UNITED STATES PATENT AND TRADEMARK OFFICE

APPLICATION NO.	FILING DATE	FIRST NAMED INVENTOR	ATTORNEY DOCKET NO.	CONFIRMATION NO.
10/717,974	11/21/2003	Bo Yeon Kim	9988.081.00-US	8004
30827	7590	05/10/2006	EXAMINER	
MCKENNA LONG & ALDRIDGE LLP			HANSEN, JAMES ORVILLE	
1900 K STREET, NW			ART UNIT	
WASHINGTON, DC 20006			PAPER NUMBER	
			3637

Office Action Summary

DETAILED ACTION

REPLACEMENT SHEET
10/717,974

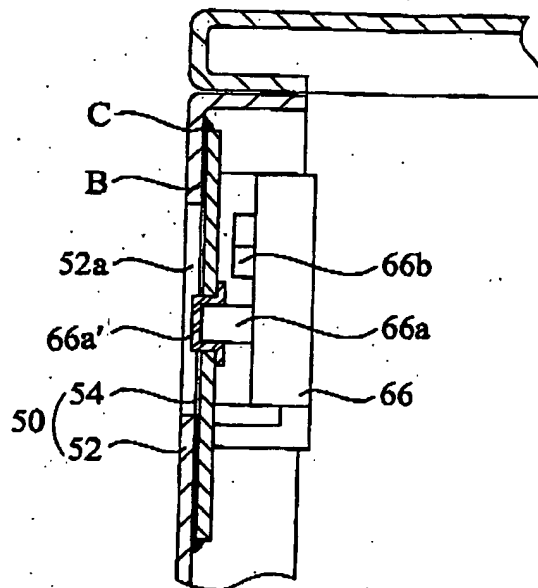
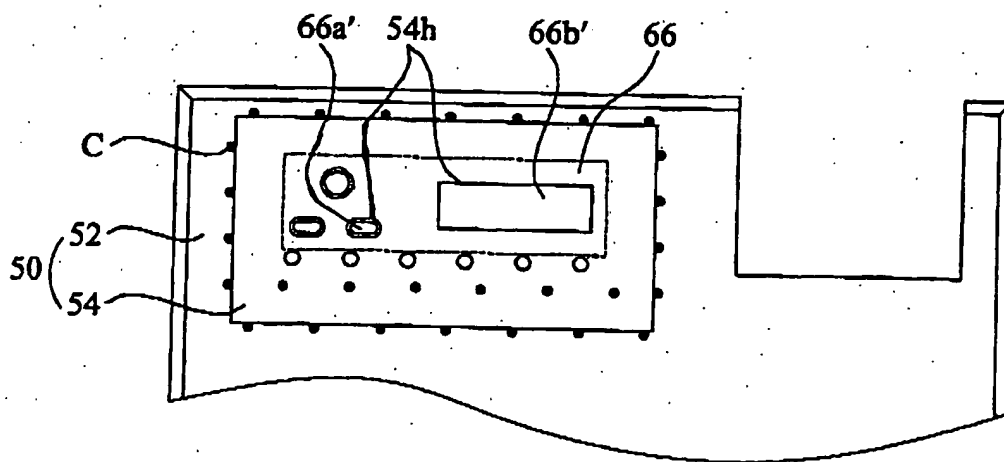
2. A replacement sheet of drawings was received on March 3, 2006. The examiner, for examination purposes, approves these drawings.

Approved for
examination purposes.
Apr 5/9/06
